CITY of NOVI CITY COUNCIL

Agenda Item 3
September 24, 2018

SUBJECT: Approval of the request of Cambridge of Novi, LLC, for Villa D'Este, JSP17-52, with Zoning Map Amendment 18.718, to rezone from RA (Residential Acreage) to R-1 (One-Family Residential), subject to a related Planned Rezoning Overlay (PRO) Agreement, and corresponding PRO Concept Plan. The property is approximately 50.6 acres and is located east of Napier Road on the north side of Nine Mile Road. The applicant is proposing a 41-unit single-family housing development in a gated community.

STORM WATER MANAGEMENT PLAN

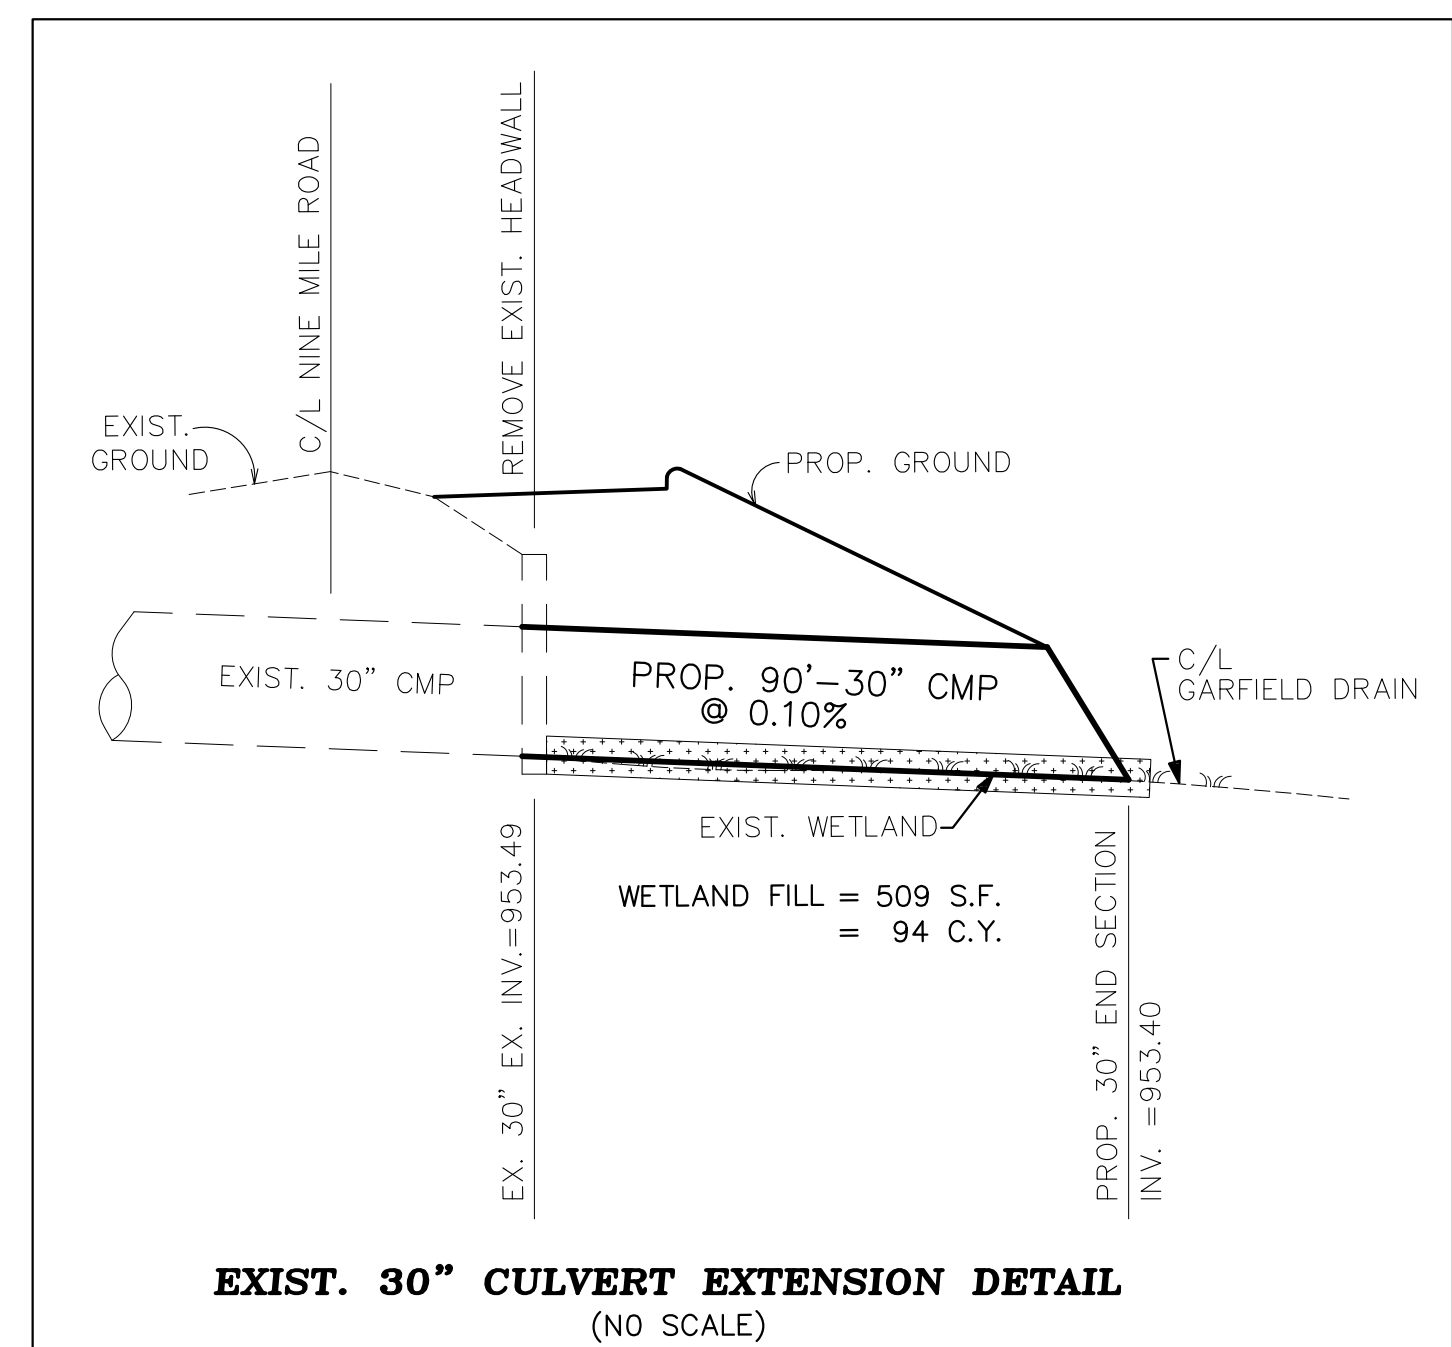
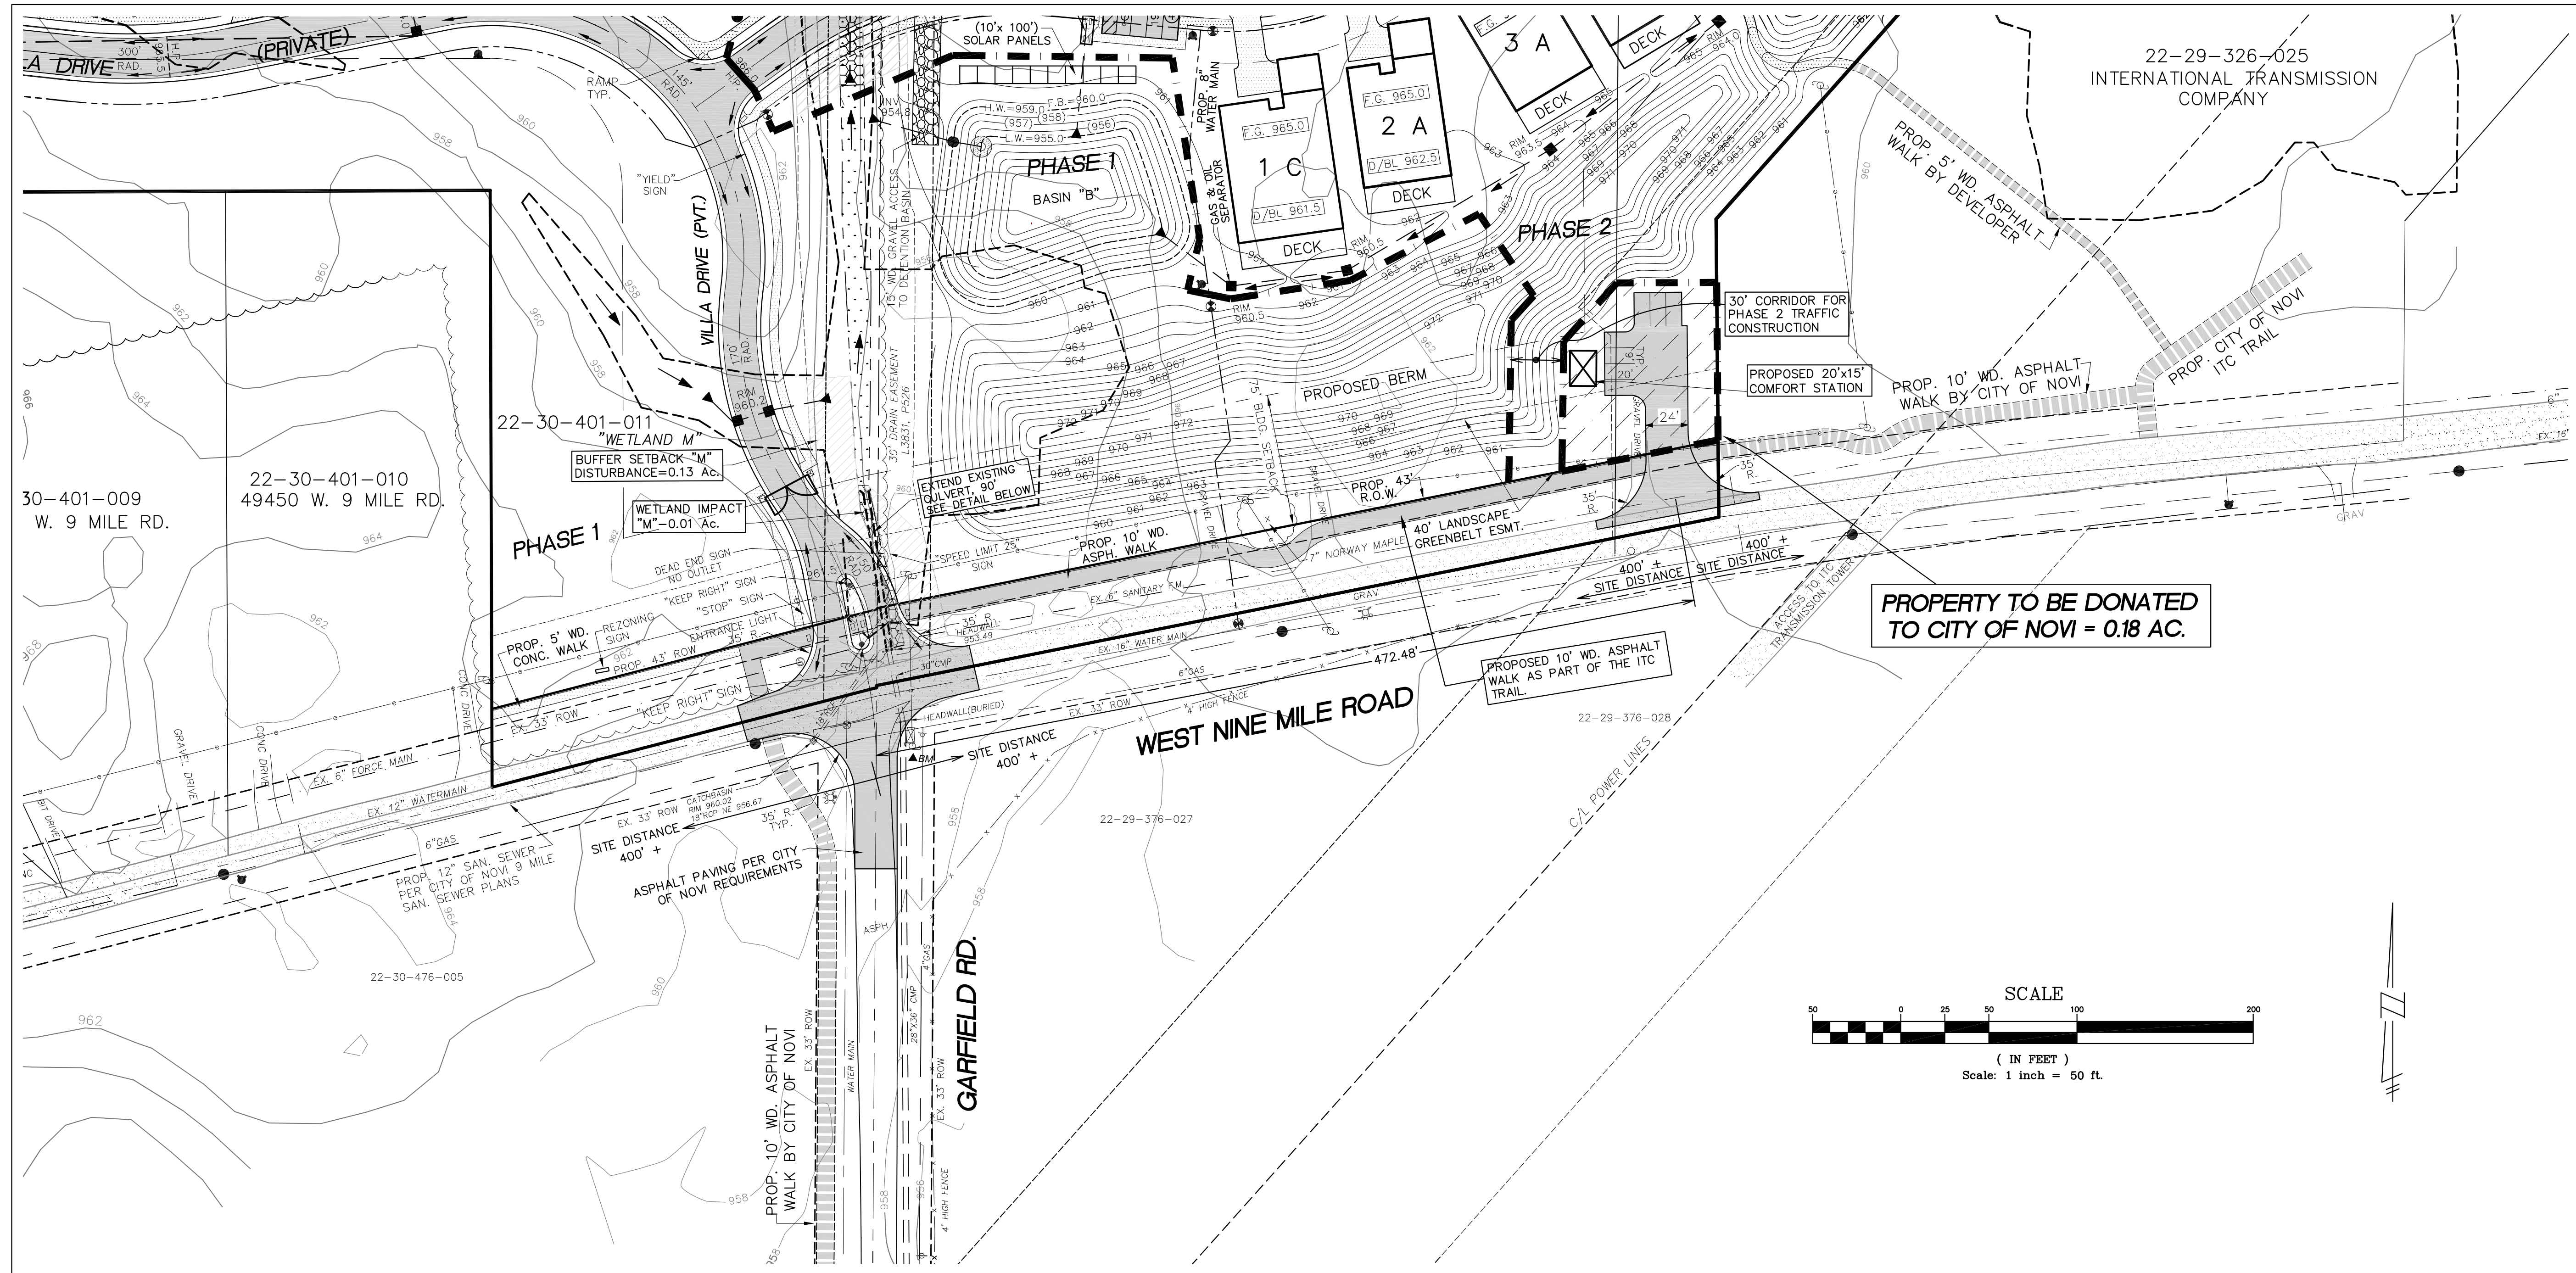
2. Revise the Emergency Access Drive profiles and details on sheets 2 and 3 to be consistent with the plan view which shows a 5-foot walk centered on the 20-foot emergency access drive.

- 21. - 25. Storm Water Management Plan has been provided (sheet 3) with details, calculations, and maintenance design parameters as specified. Please note that more detailed grading is being provided with the current submittal and as a result the detention basin location have changed from the plans submitted for pre-application review.

sheet no.
LP-1

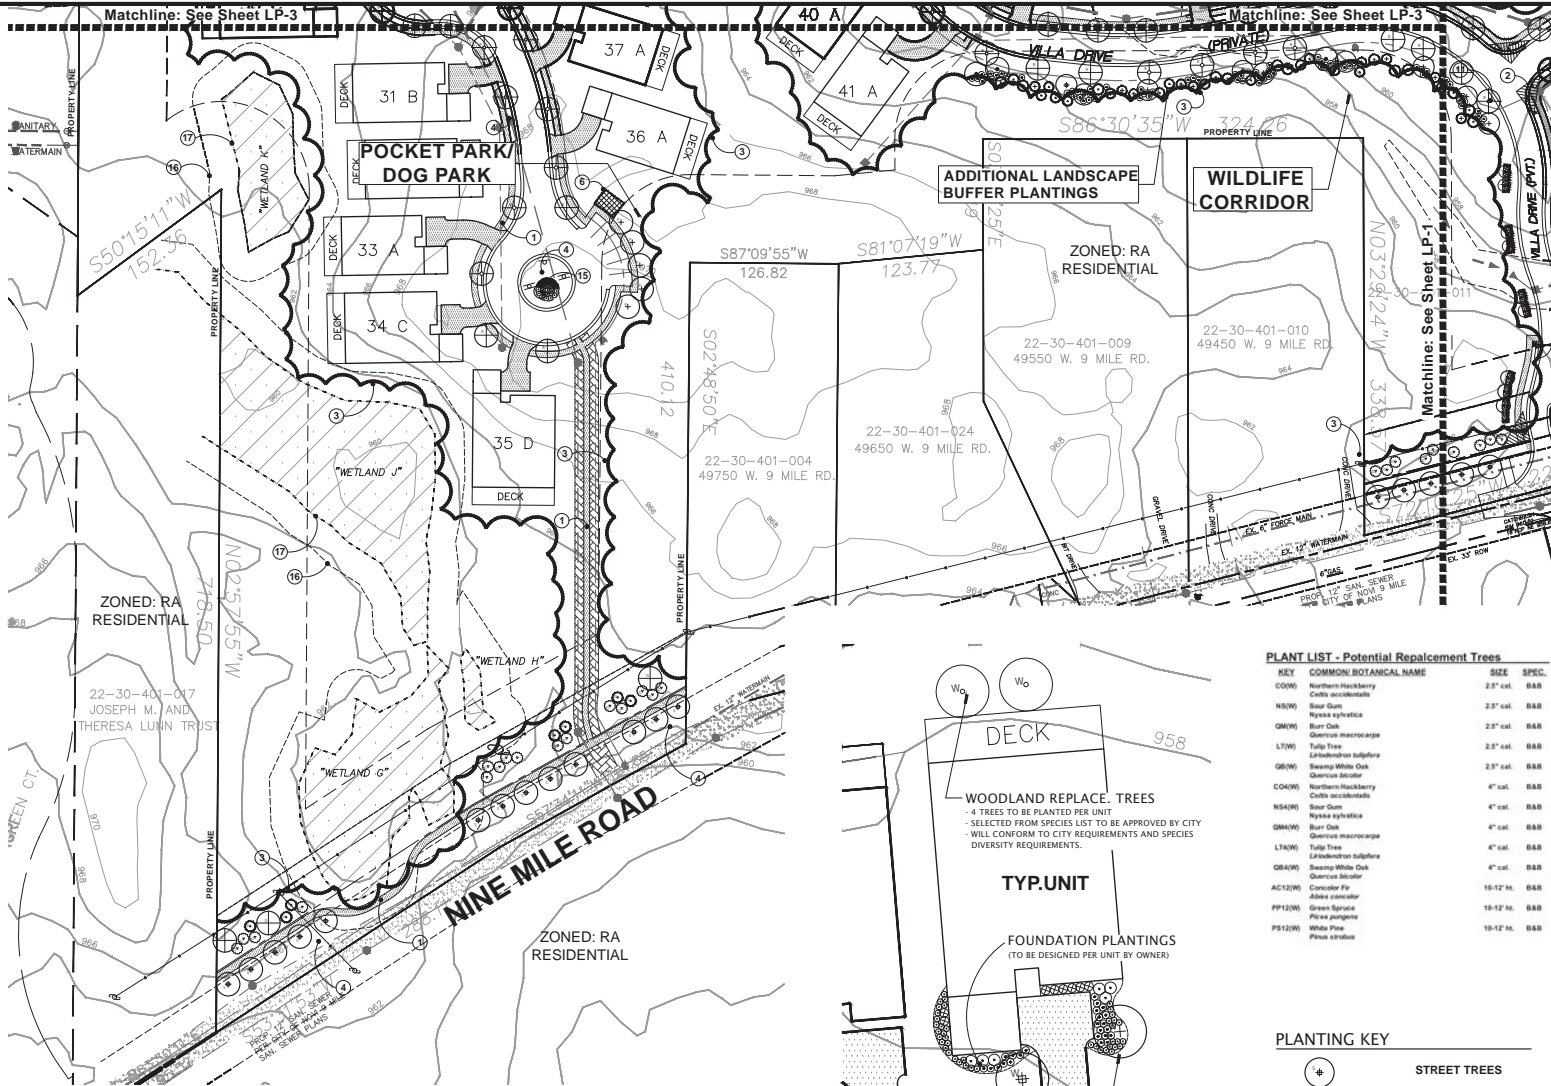
Please show this landscape deviation on the sheet LP-1, with the approval date.

sheet no.
LP-2

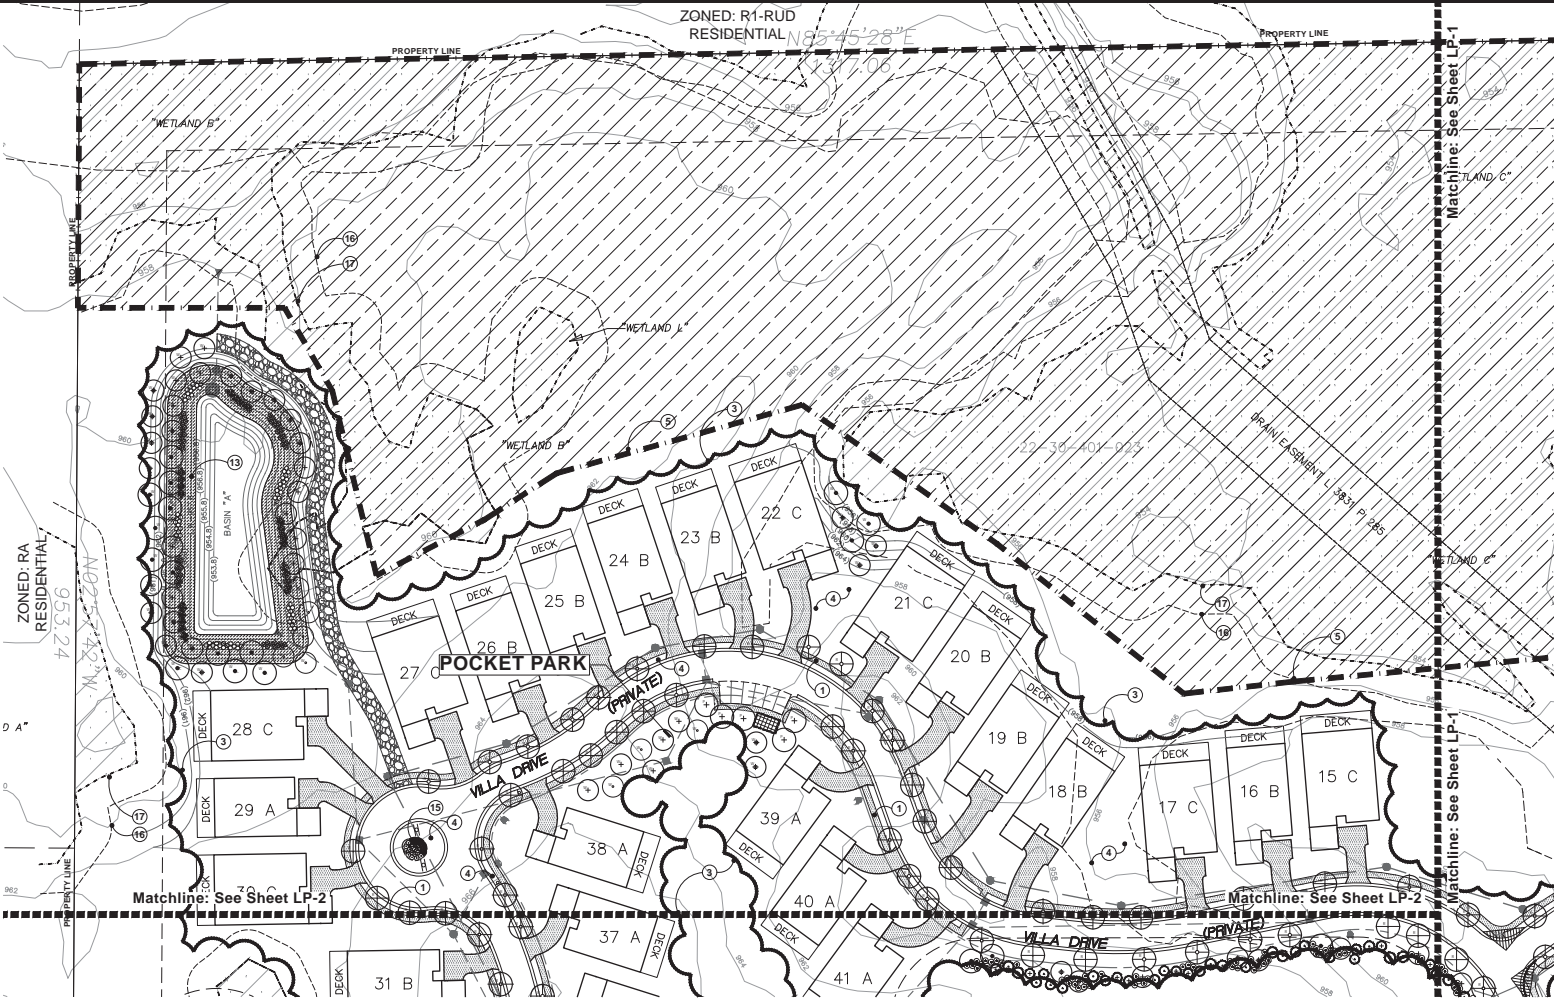
This comment has been partially addressed. The Conceptual Landscape Plan (Sheet LP-2) contains a list of Potential Replacement Trees. It should be noted that the following trees listed are not acceptable as Woodland Replacement Trees per the City of Novi:

4. All proposed Woodland Replacement tree material shall meet the species requirements in the *Woodland Tree Replacement Chart* (attached). With regard to the Potential Replacement Trees Plant List on Sheet LP-2, two species of evergreen being proposed are not acceptable as Woodland Replacement Tree material:
 - a. Concolor fir (*Abies concolor*); and
 - b. Green spruce (*Picea pungens*).
